DIRECTED RESEARCH
FOR
BALANCE RESOURCES AND DEMAND STANDARD'S
PROCEDURES FOR DEVELOPING
FREQUENCY-RELATED LIMITS

DRAFT 4

Priority-based Control Engineering (PCE)

Consortium for Electric Reliability Technology Solutions (CERTS)

Figure 1

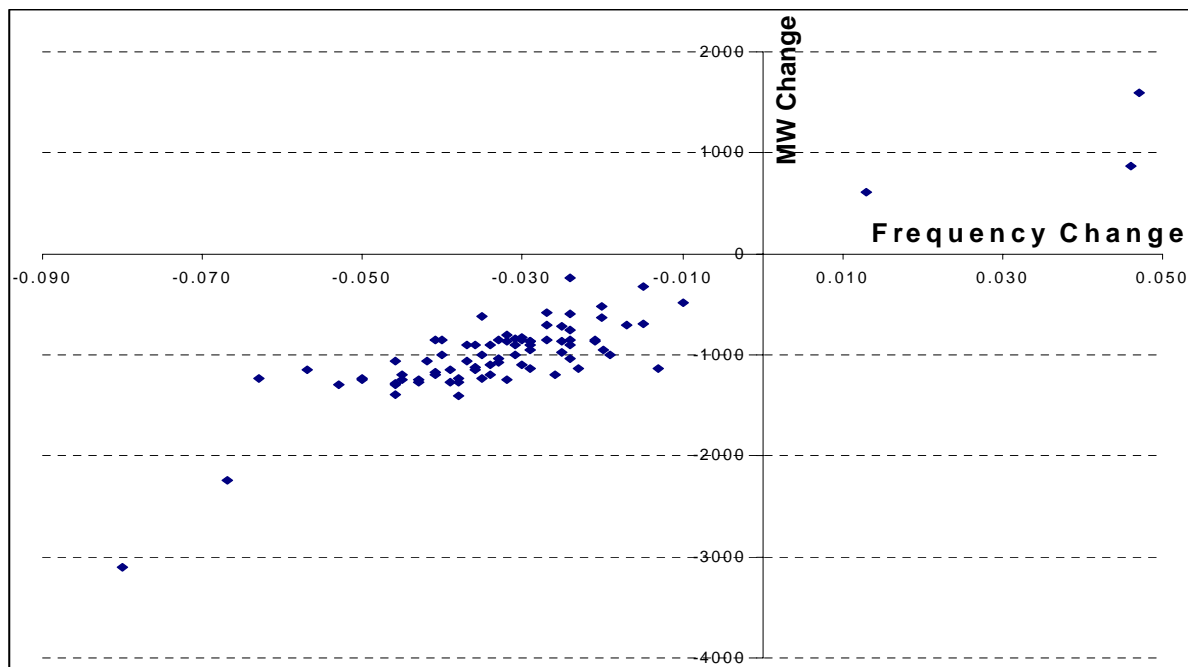
The chart in Figure 1 shows plots of the frequency change versus MW change for the samples used to measure frequency response of the Eastern Interconnection (see Comment 3 in Outstanding BRD SDT Comments).

3) Section V.1 (In regard to the plot of frequency response events):

Might want to add a trend line w/ slope and correlation coefficient.

Figure 2

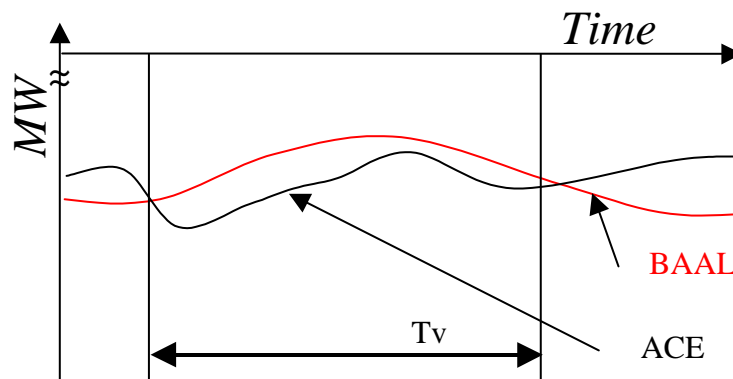
In scenario A (Figure 2), the BA fails to return ACE above its BAAL in time to satisfy the T_{vb} time limit:

Figure 3

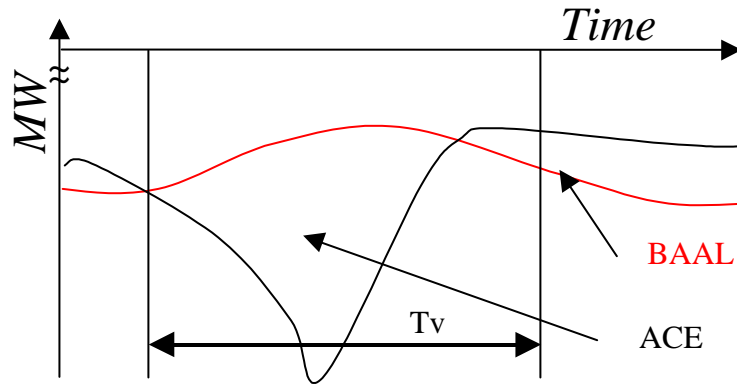
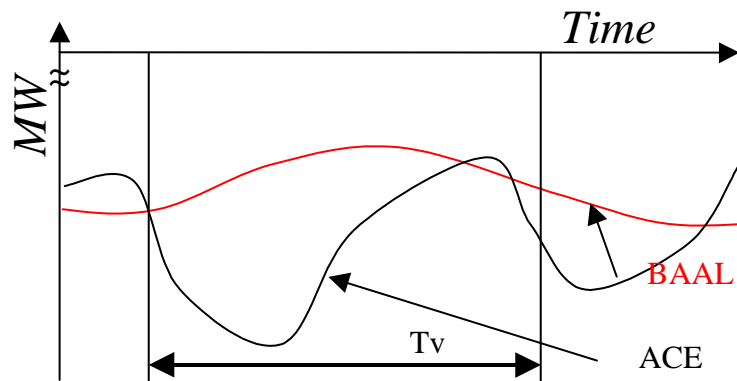
In scenarios B (Figure 3) and C (Figure 4) the BA satisfies the T_{vb} time limit. In scenario B, it operates with a very negative ACE for an extended period of time, particularly when frequency error magnitude becomes very large. In scenario C, it operates with a negative ACE that exceeds

its BAAL for a time interval shorter than T_{vb} , then for a period of time bounds its ACE to its BAAL, but then its ACE exceeds its BAAL in the same T_{vb} interval again.

PCE believes that in scenarios B and C the risk of reaching FRL imposed on the Interconnection by the BA is greater than in scenario A. This creates a difficulty in definitively evaluating the risk contributed to the Interconnection at a given frequency by a given BA and raises the question whether a T_{vb} that adequately protects the Interconnection in all situations without imposing undue control requirements can be determined.
